# Work Order ID 83088

Item Name: Crosstube Aft

DRAWING NO. D212-664-241	TITLE CROSSTUBE ASSY (205/212 HI AFT)	REV. D	DART AEROSPACE LTD ENGINEERING ORDER		D.E.O. NO. D212-664-241-D-1	SHEET NO. SHEET 1 OF 2	SCALE NTS
DRAWN	CHECKED	MFG. APPR.	APPROVED		DE APPR.		
DATE 11.04.07	DATE 11.04.11	DATE 11.04.12	DATE 11/04/12		DATE 11.04.12

ADD AN INSPECTION WINDOW TO UNDERSIDE OF CROSSTUBE.

D212-664-241/-241B  
ASSEMBLY DETAIL

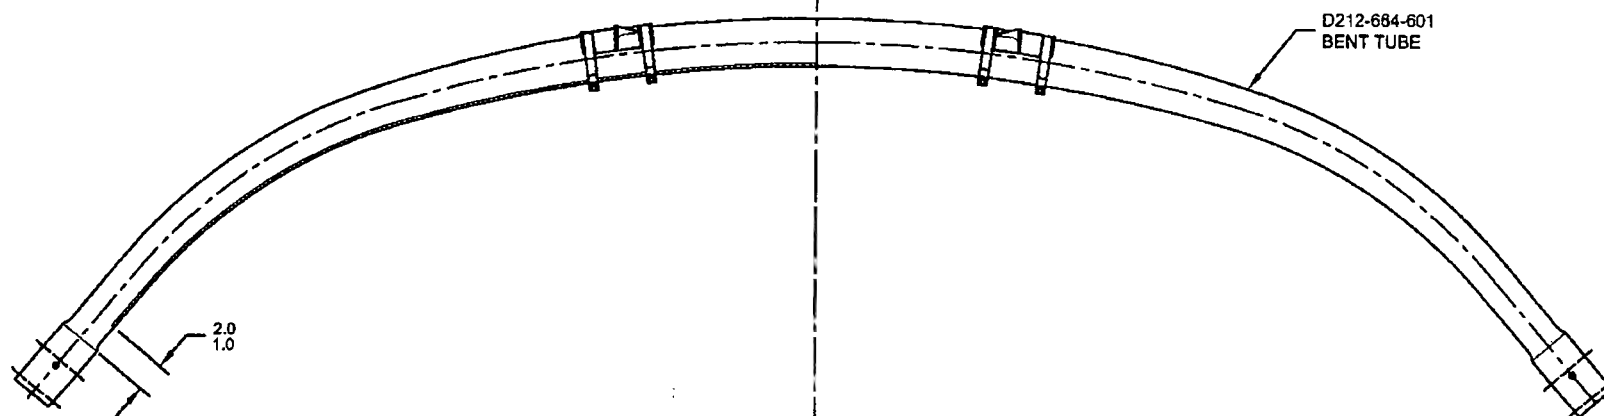
NOTES 2 OF SHEET 1 IS AMENDED AS FOLLOWS:

- 2) FINISH: CHEMICAL CONVERSION COAT PER DART QSI 005 4.1  
PRIME INSIDE AND OUTSIDE PER DART QSI 005 4.2  
MASK UNDERSIDE OF CROSSTUBE AS SHOWN (HATCHED AREA) AND  
PAINT OUTSIDE PER DART QSI 005 4.2  
REMOVE MASKING AND APPLY CLEAR COAT

- 2) FINISH: CHEMICAL CONVERSION COAT PER DART QSI 005 4.1  
PRIME INSIDE AND OUTSIDE PER DART QSI 005 4.2  
PAINT OUTSIDE PER DART QSI 005 4.2

MASK AREA PRIOR TO PAINTING,  
REMOVE MASKING AFTER PAINT  
AND APPLY CLEAR COAT

**FIGURE 1: SUPPORT INSTALLATION**

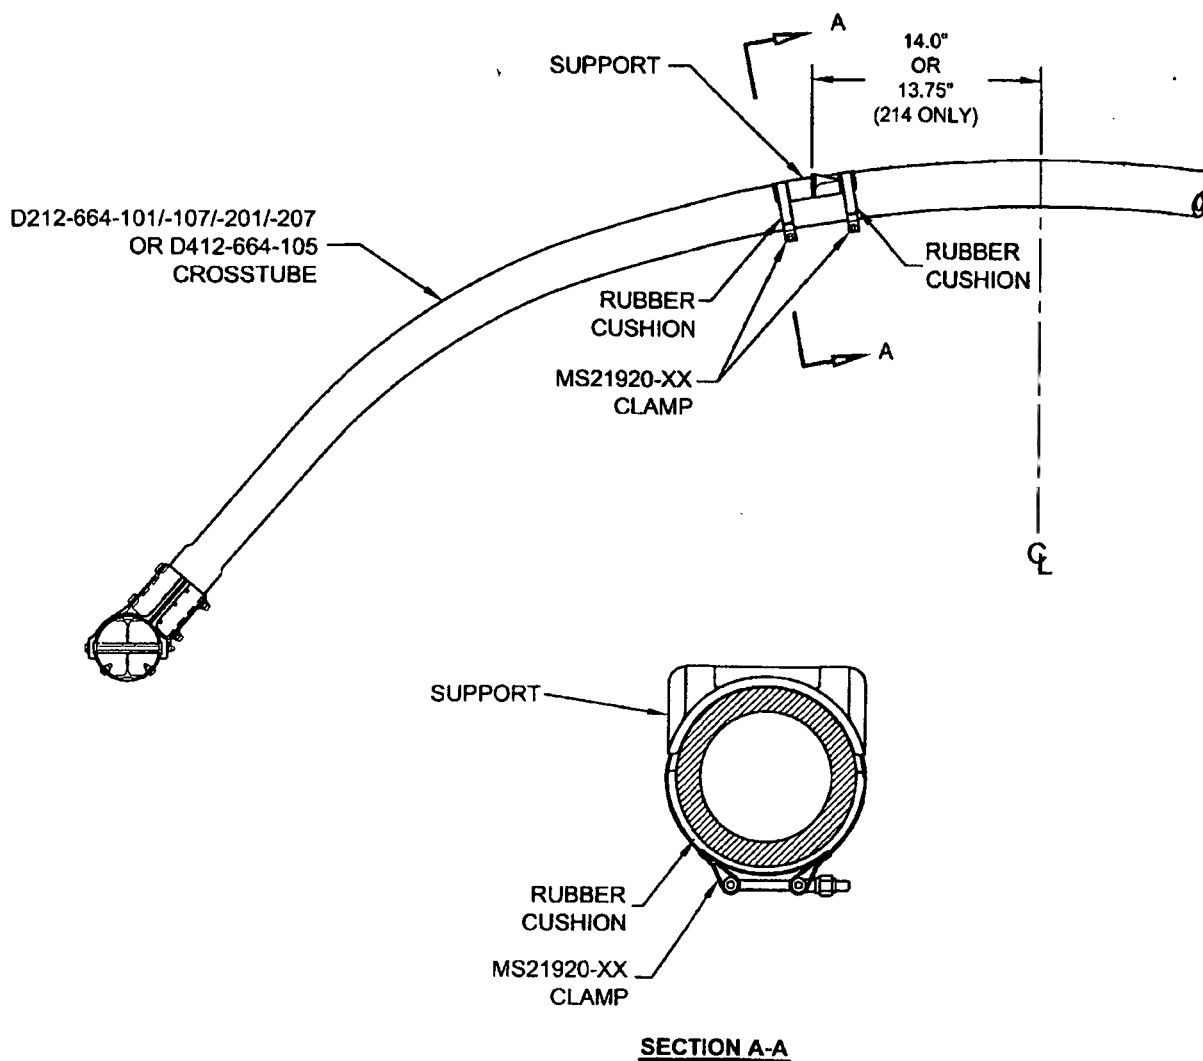
For the crosstubes listed above, section 32.4 of ICA-D212-664 is amended as follows. Use Figure 1 of this service instruction and Figures 32-2 to 32-9 of ICA-D212-664 for further reference. For crosstubes of an earlier change number, it is recommended that if the supports are removed, the supports should be reinstalled using the procedure listed below.

- 32.4.1 Locate the area on the crosstube for installation of support (see Figure 1 of this service instruction). For D212-664-101/-107/-201/-207 and D412-664-105 crosstubes, the outward face of the support tabs should be 14.0" (355mm) from the crosstube center for 204/205/210/412/UH-1 aircraft. For installation on 214B/B-1 aircraft, the outward face of the support tabs should be 13.75" (349mm). Ensure paint finish of crosstube is intact; touch up as required per Chapter 5 (5.3.9) of ICA-D212-664.

- 32.4.2 If present, remove any paint/primer on bottom of supports. Abrade mating surfaces of support and crosstube with 400-grit sandpaper. Saturate a clean cloth with MEK or 4105S Wash'n'Wipe Degreaser or equivalent and wipe until there is no residue.

- 32.4.5 Apply a 0.04" to 0.07" thick layer of Proseal 890 Class B or AMS-S-8802 Class B sealant underneath applicable support and install support as shown in Figure 1 of this service instruction.

- 32.4.6 Install the clamps opposite to crosstube support as shown in section A-A of Figure 1. Install rubber cushions underneath each clamp around the bottom circumference of the crosstube up to the crosstube centerline. Torque clamps 80-100 in-lb (9.0-11.3 Nm). It is acceptable to use smaller or larger sized MS21920-XX clamps than those listed in ICA-D212-664, ensure that after torquing the clamps per this instruction, the nuts are in safety but not bottomed out
